# V-91 (2012)

<p><b>12125</b></p>	<p><b>VARIANCE PLAT</b>  <b>5125 TIMBER RIDGE ROAD</b></p>	<p>08-17-12</p>	<p><b>BETTERTON</b>  <b>SURVEYING &amp; DESIGN, INC.</b>                  LAND SURVEYOR PLANNING                  SUBDIVISION &amp; COMMERCIAL SITE DESIGN                  1111 SOUTH MARIETTA PARKWAY, SUITE A                  MARIETTA, GEORGIA 30060                  (678) 483-0242</p>	<p>DATE: 08-17-12</p>
	<p>LOCATED IN LAND LOT 184                  SECTION 28                  TOWNSHIP 32 N                  RANGE 8 E                  COBB COUNTY, GEORGIA</p> <p><b>DONALD &amp; NOBUKO MAC KAY</b></p>	<p>12125913.PRO</p>	<p>SEPTEMBER 17, 2012</p>	<p>12125</p>

**APPLICANT:** Nobuko Mackay **PETITION No.:** V-91  
**PHONE:** 404-406-4925, 678-314-7443 **DATE OF HEARING:** 11-14-12  
**REPRESENTATIVE:** Gary L. Smith **PRESENT ZONING:** R-30  
**PHONE:** 770-605-7152 **LAND LOT(S):** 164  
**TITLEHOLDER:** Nobuko Mackay **DISTRICT:** 1  
**PROPERTY LOCATION:** On the north side of **SIZE OF TRACT:** 1.625 acres  
 Timber Ridge Road **COMMISSION DISTRICT:** 3

**TYPE OF VARIANCE:** 1) Waive the minimum lot width at front setback line from the required 75 feet to 20 feet for Tra

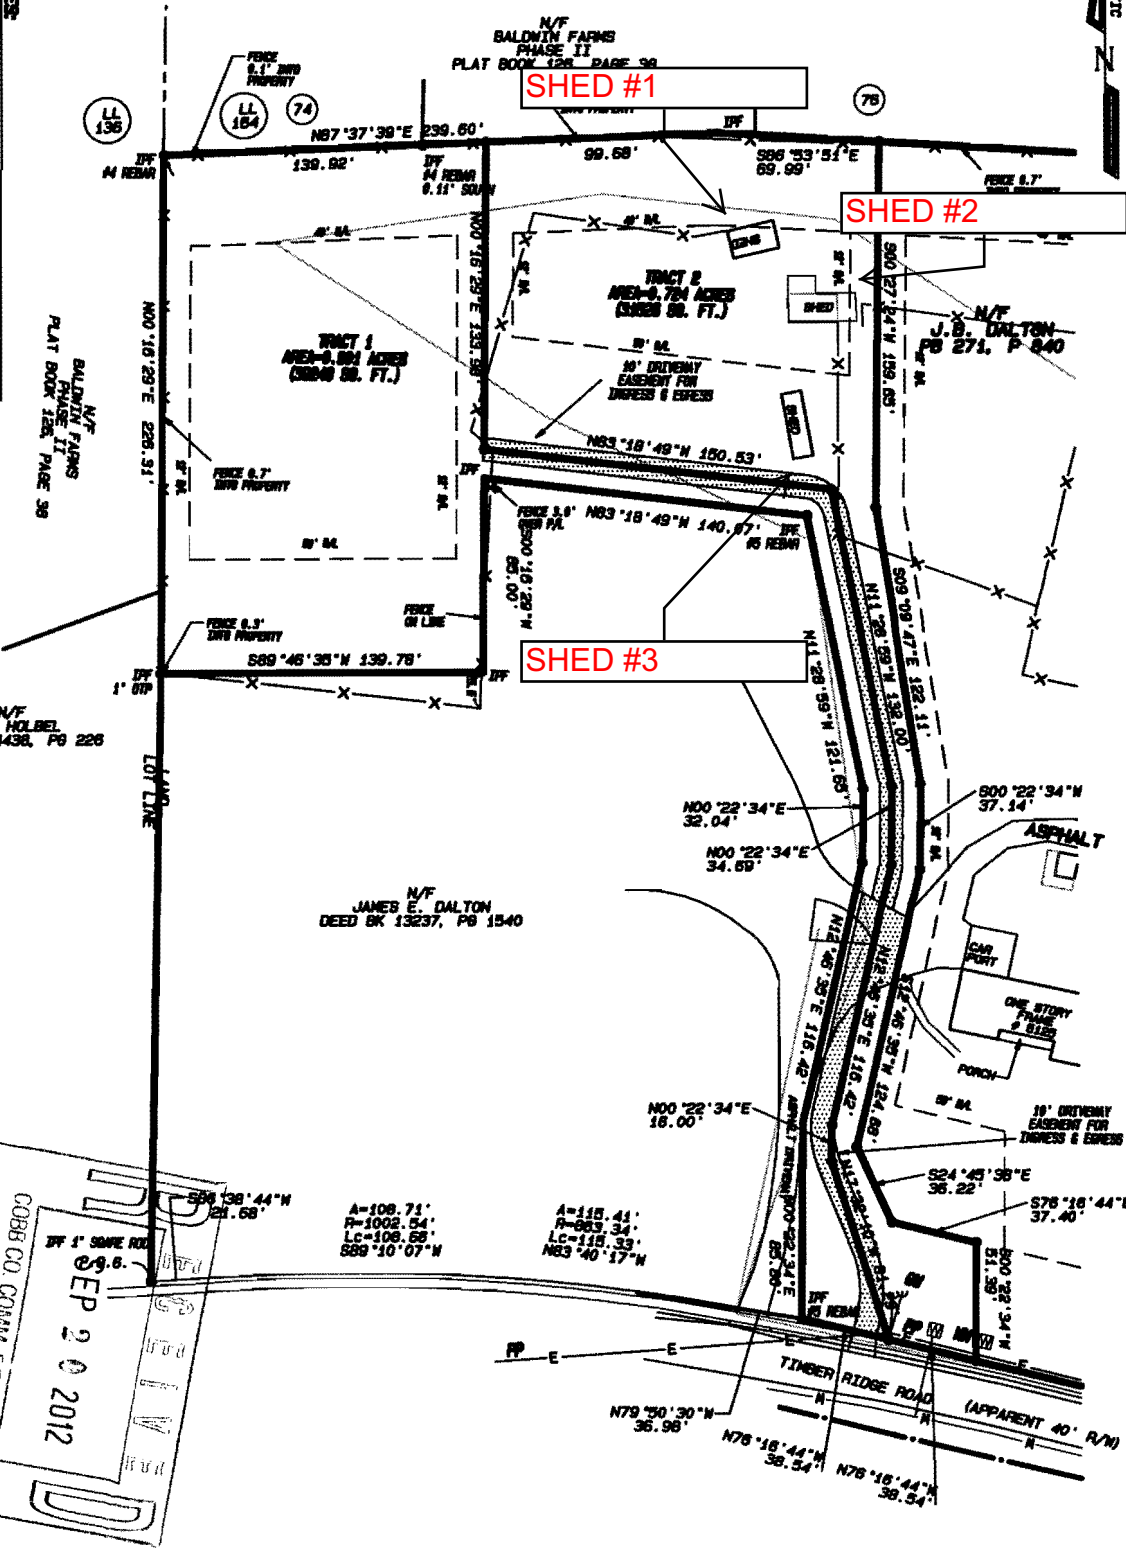
**TRAFFIC:** Recommend one shared driveway for the proposed subdivided lots.

Recommend driveway meet the Residential Driveway Standard, Cobb County Detail 116R.

**SITE PLAN REVIEW:** No comments regarding the accessory structure setbacks; however, the subdivision of Tracts 1 and 2 shown constitutes a 3 lot subdivision based on the previous lot split that was recorded in Plat Book 271, Page 840. Such a subdivision is subject to full site plan review prior to any plat recording.

**STORMWATER MANAGEMENT:** The original single-lot split is acceptable. However, the proposed additional lot split is effectively creating a subdivision outside the requirements of the County's Development Standards and Stormwater Management Regulations. If this variance is approved, the development would be required to meet those requirements. The required detention pond must be placed on a separate parcel with direct access to the public right-of-way. It appears that this would require purchase of additional property from the adjacent parcel owner at 5138 Baldwin Terrace. Also, the pond lot requirement will significantly impact the layout for Tract 1 due to the reduced setbacks and possibly require a rezoning if the necessary pond area results in the remaining lots sizes to fall below the R-30 requirement.

**SEWER:** Two lot subdivision requires connection to public sewer. Easements to public sewer will be required, which are the responsibility of the owner.
